**TOWN OF HARVARD
PLANNING BOARD AGENDA
MONDAY, JANUARY 8, 2024 @ 7:00PM**

**RE: 184 Ayer Road
Stormwater Site Plan Review
Harvard, MA**

Reference: Stormwater Site Plan Review
184 Ayer Road
Harvard, Massachusetts
B+T Project No. 3241.05

SHEET NO. **C1.1**

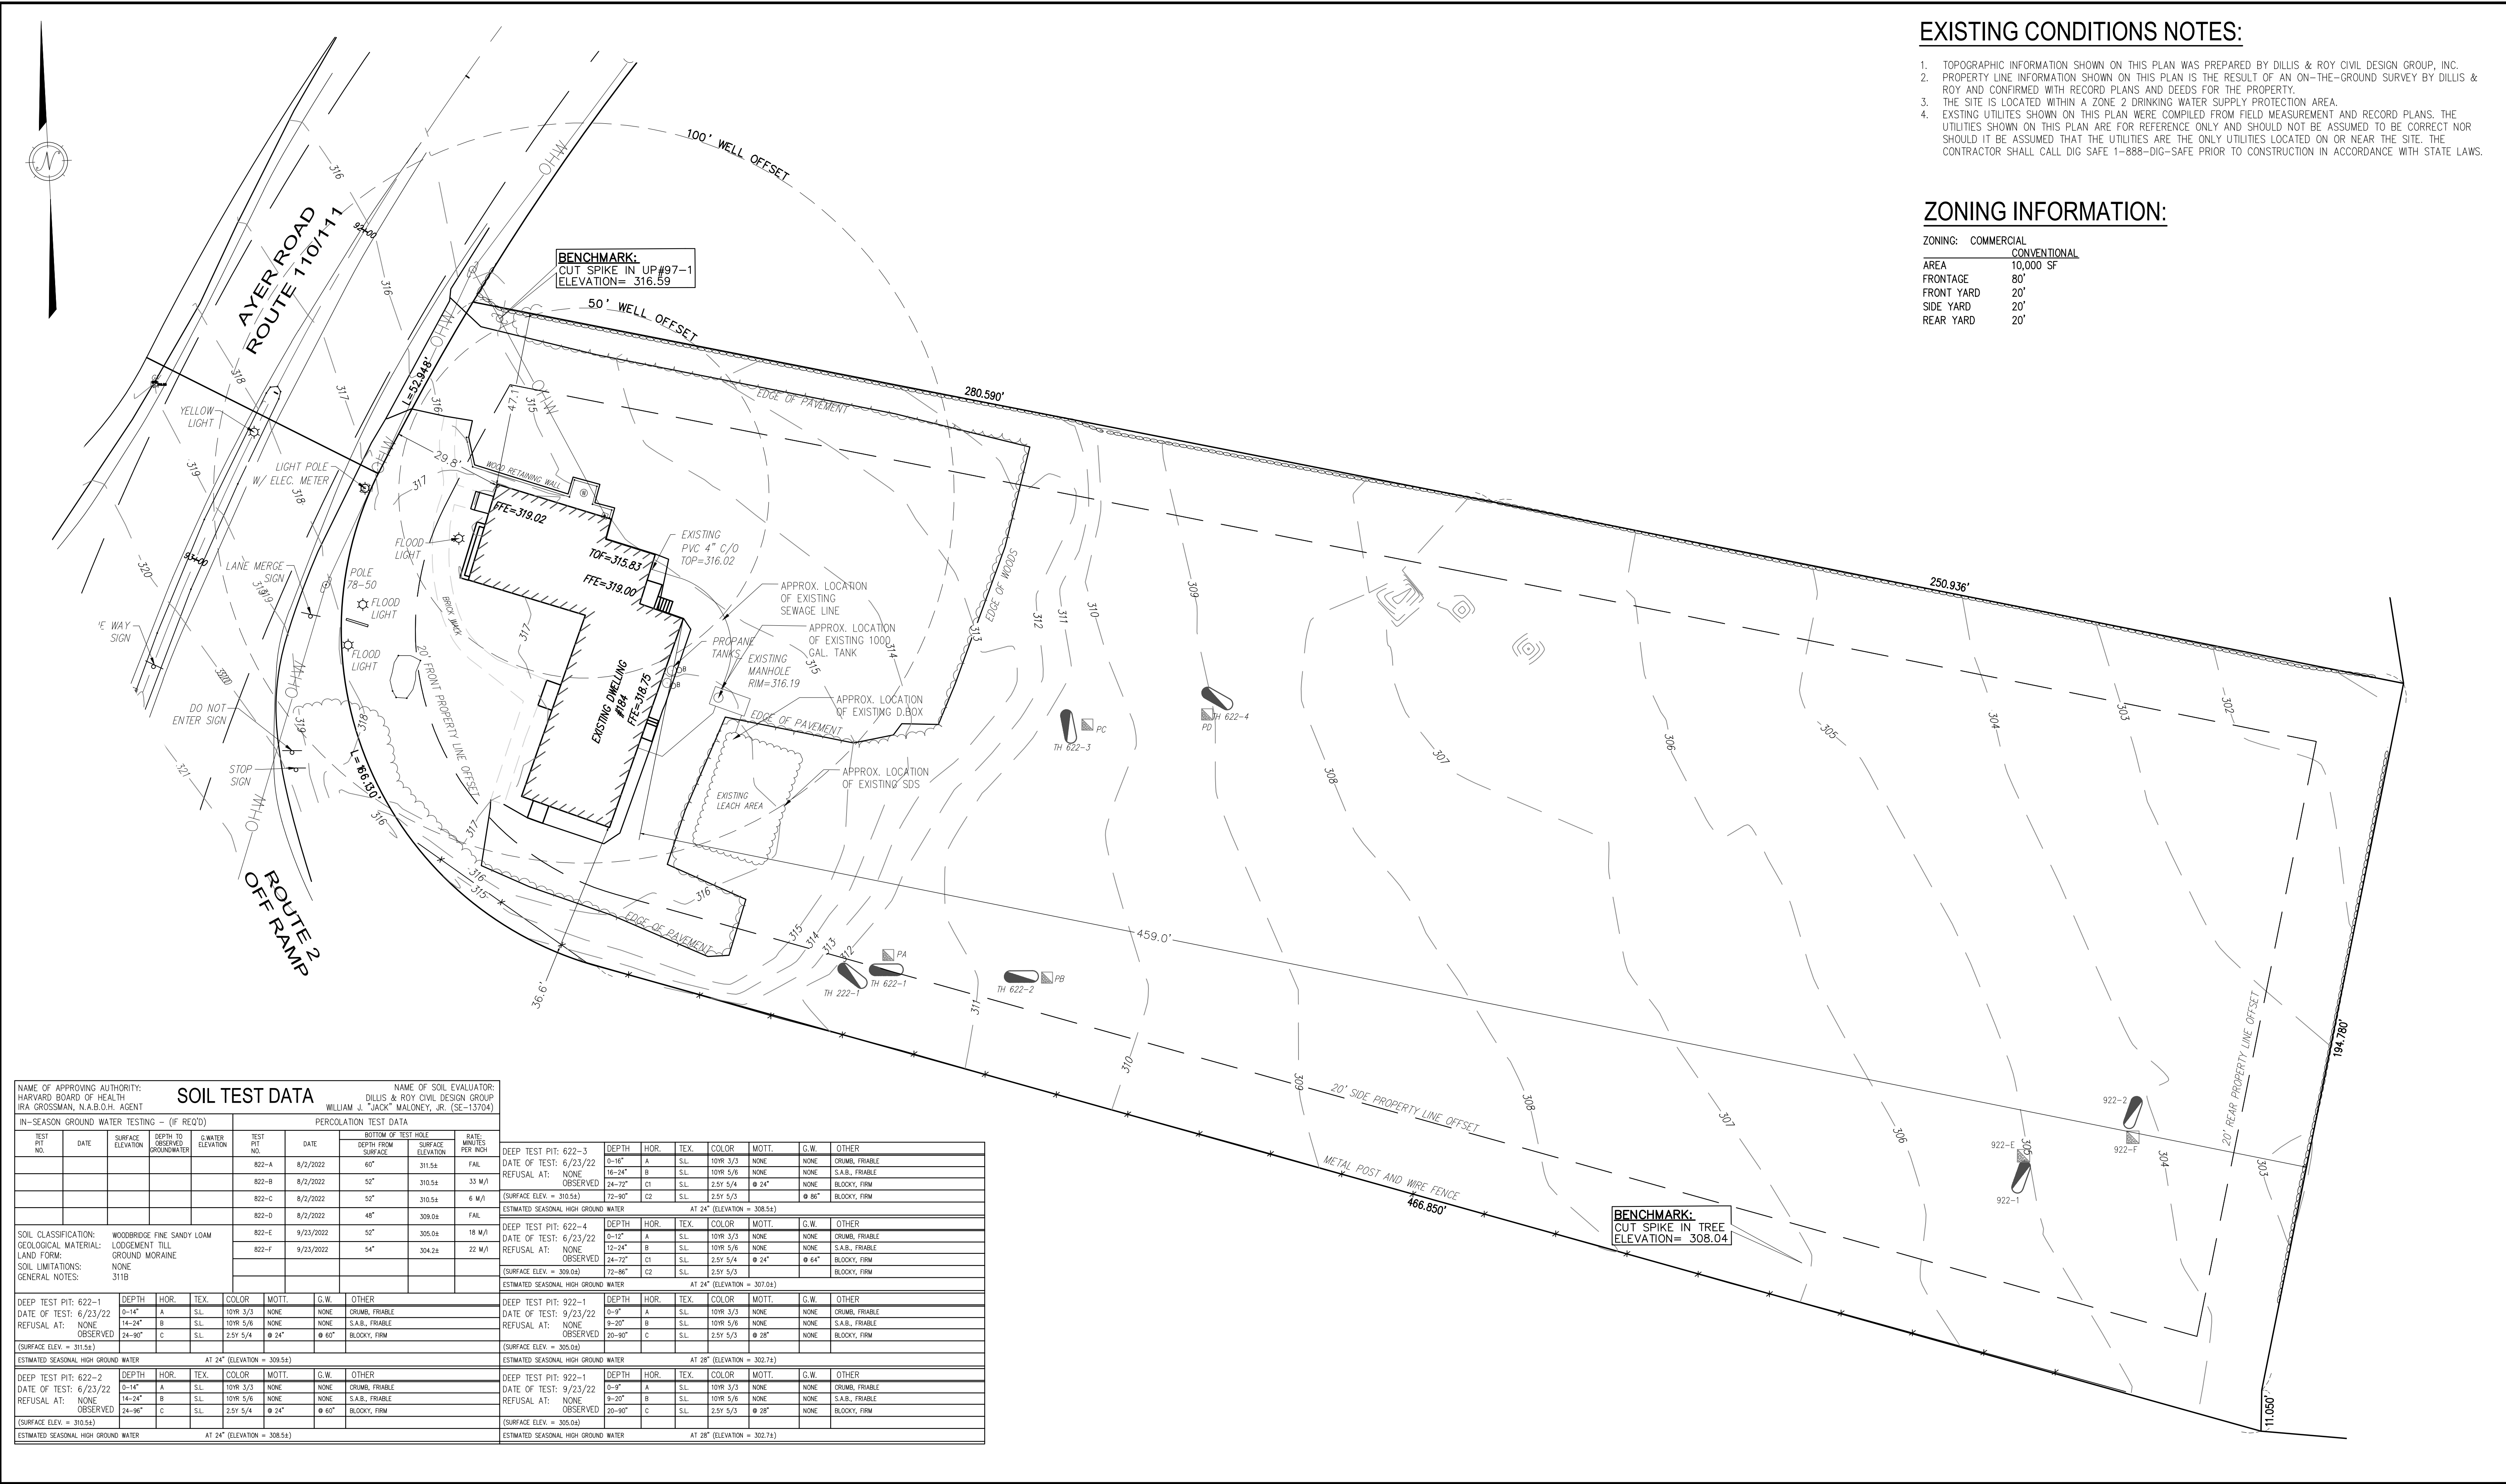
7. *Test pits appear to have been conducted based on symbology used on the existing conditions plan. This information has not been provided with stormwater report. We request that all available soil and estimated seasonal high groundwater elevation information be provided for review.*

D&R – Plan Sheet C1.1 has been revised to include test pit data.

JOB NO. 6632-C
 DRAWING NO. 6632-C-LAYOUT
 SHEET NO. **C2.0**

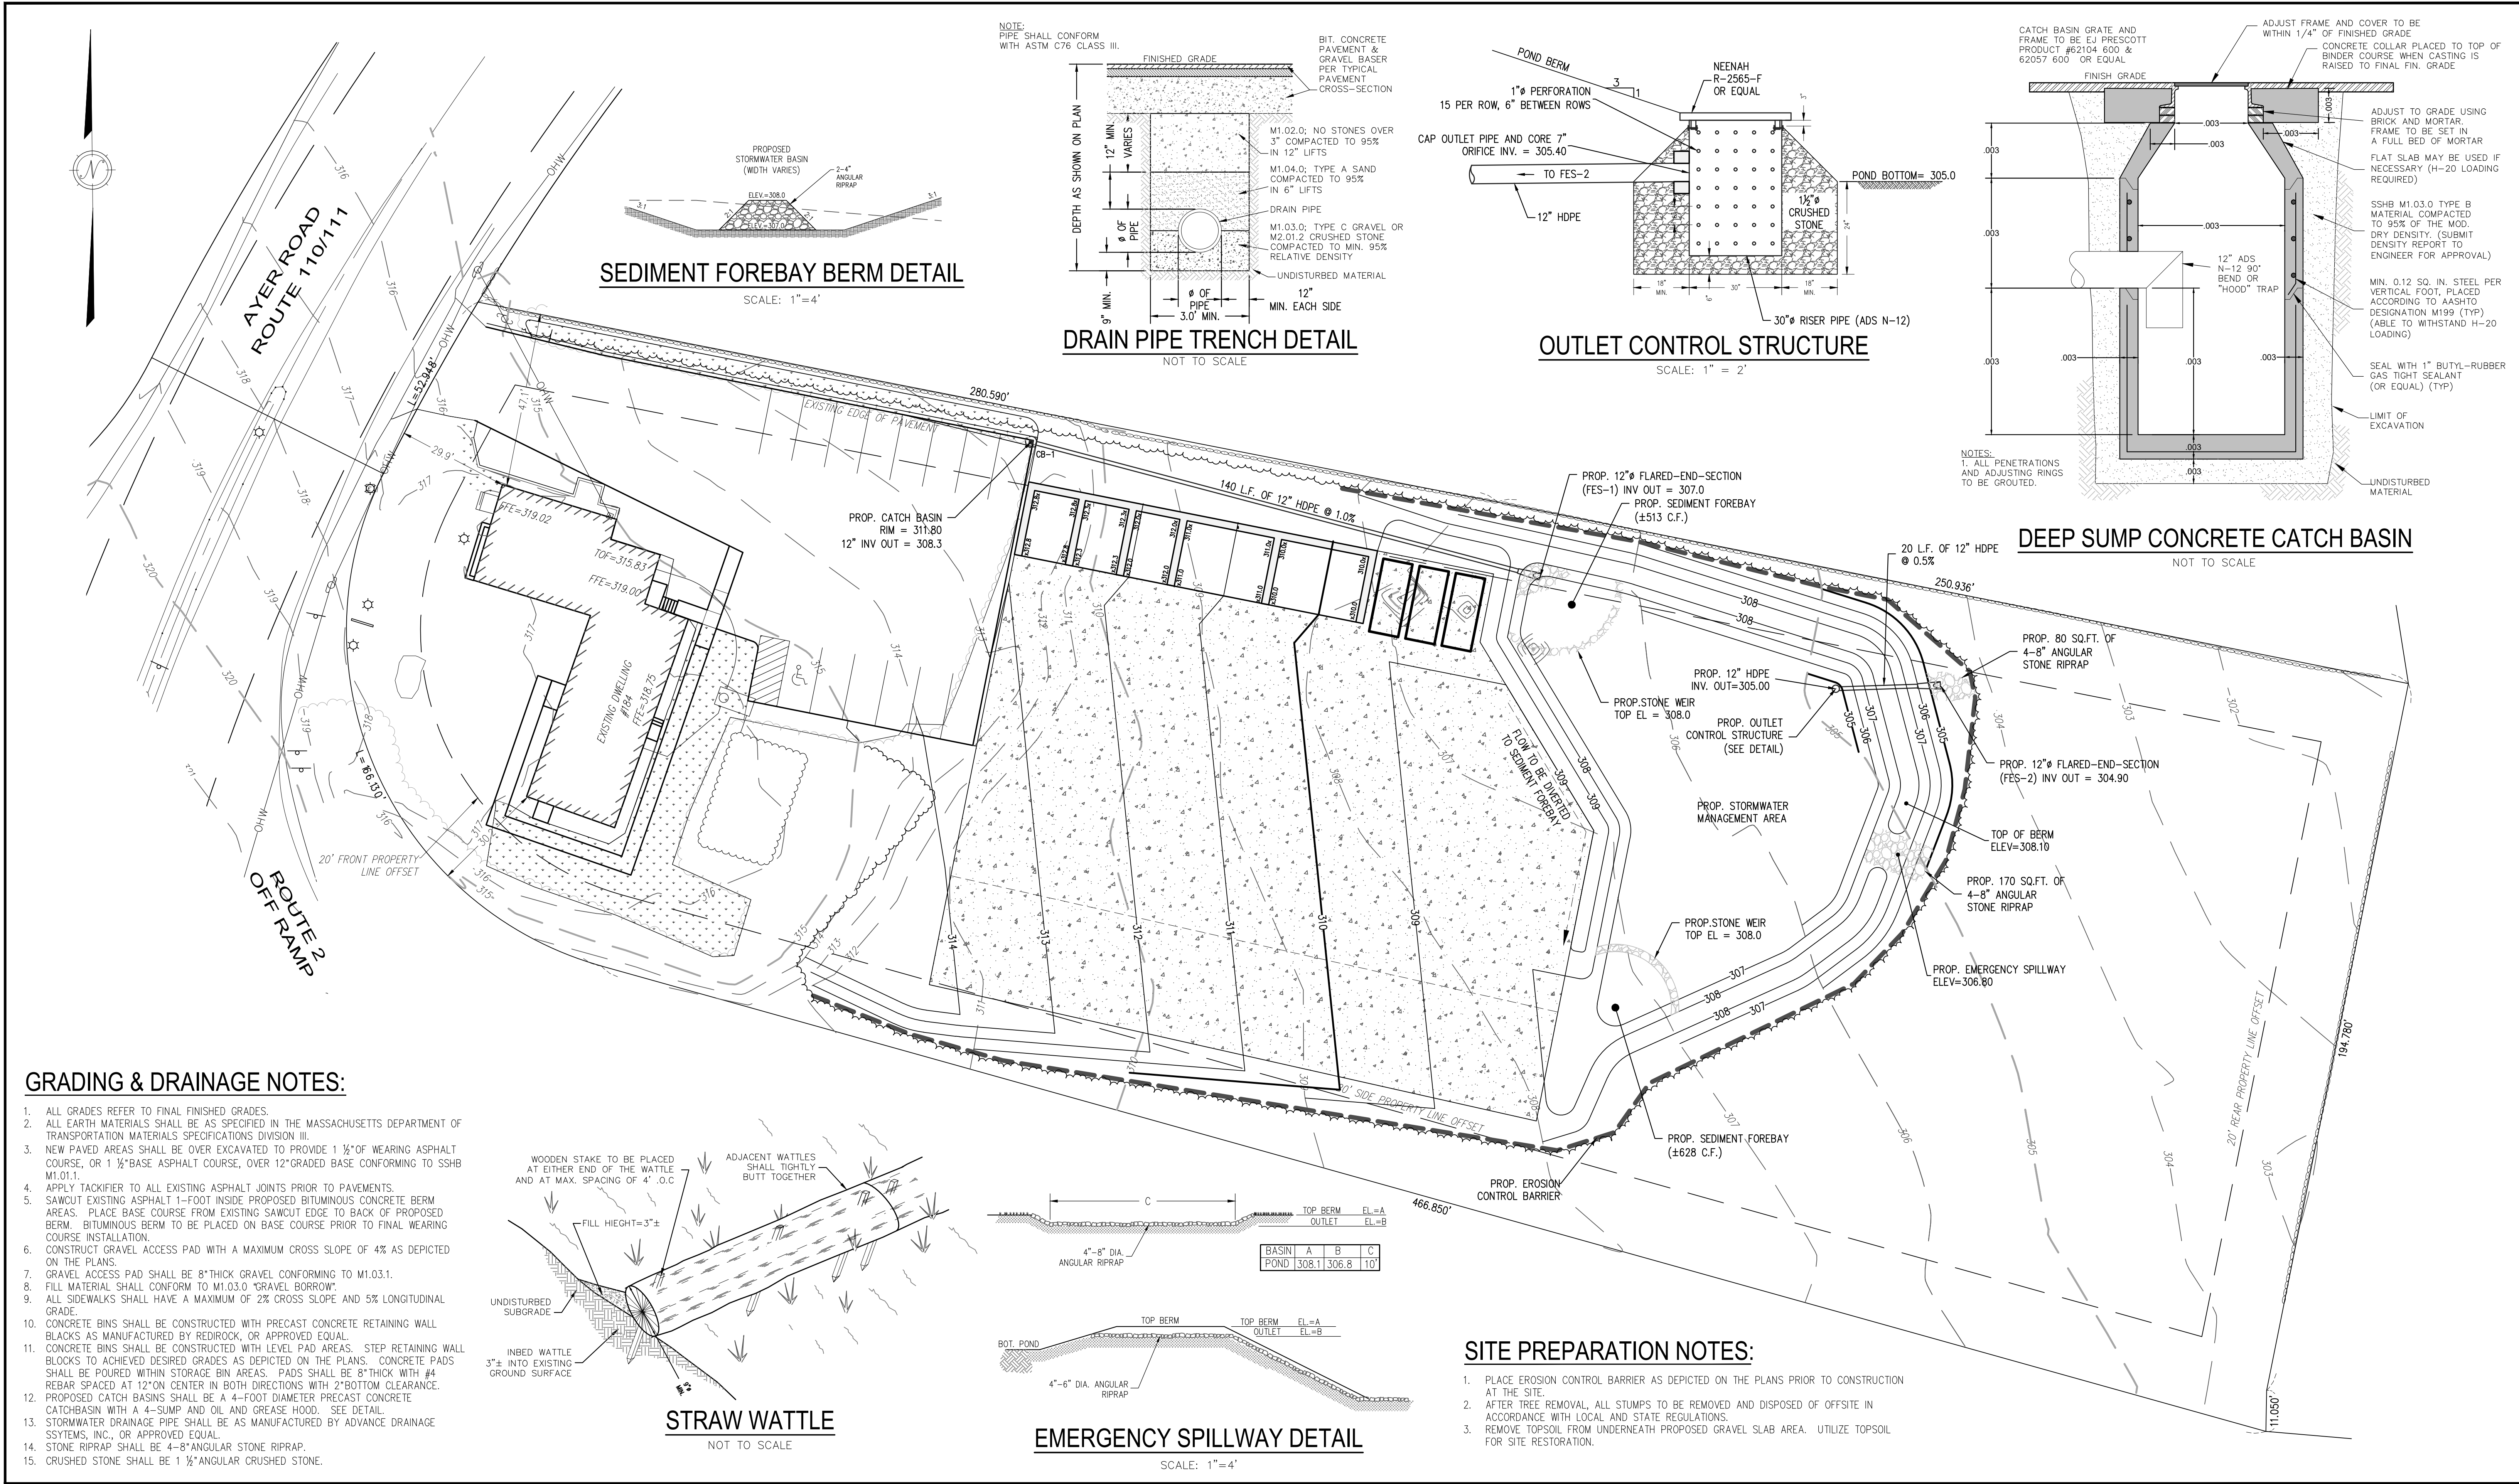
8. *The long-term pollution prevention plan indicates that snow storage areas are depicted within the plan set. These areas do not appear to be included as indicated. We request that the Applicant clarify protocols for snow storage and removal.*

D&R – Plan Sheet C2.0 has been revised to depict locations for snow storage on-site.
